Mega Denim Ltd. (Extension)

10 September 2023

1. Building-2: Six storied (G+5) reinforced concrete building.
2. Building-3 (Hydrant Building): Three storied (B+G+2) reinforced concrete building with a basement.

Foundation stress exceeds normal design limit

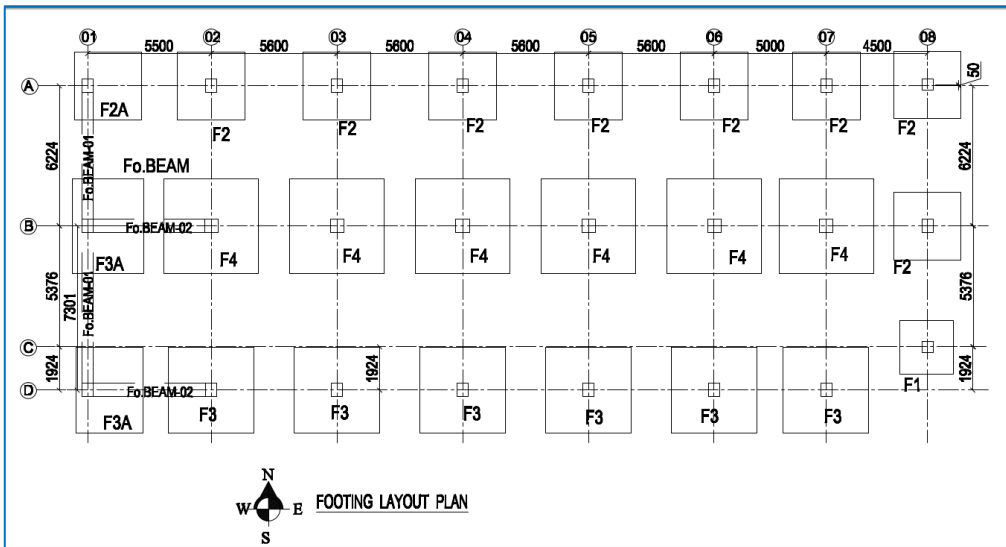
Cursory calculation indicates that bearing of internal footings exceeds the normal design limit considering ultimate Bearing Capacity of soil 3.25 tsf for 6 kPa live load on 1st floor & 3 kPa on typical floors. The building engineer to review design, loads and foundation stresses.

Storage on first floor

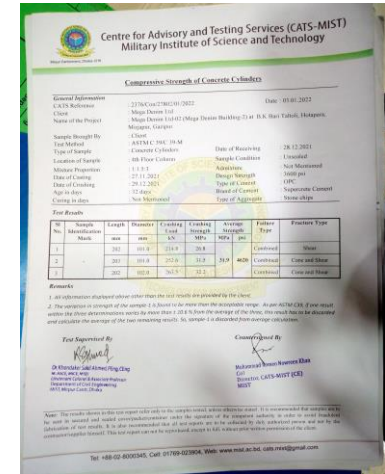
Currently, the first floor of the building is being used for finished cartoon store. As per BNBC, the minimum floor live load for light storage is 6 kN/m² (125 psf). But the storage area of the building is designed for 3 kN/m² live loads. Moreover, the factory has provided only 2 sets of concrete cylinder test report from column & slab, which doesn't comply the frequency of testing requirement of BNBC (section- 5.12.2).

Building engineer is required to revise the floor live load plan following BNBC storage live load requirement and revise the design documents based on in-situ material strength. Verify the in-situ material strength by taking 100 mm core from lower tier columns of the building.
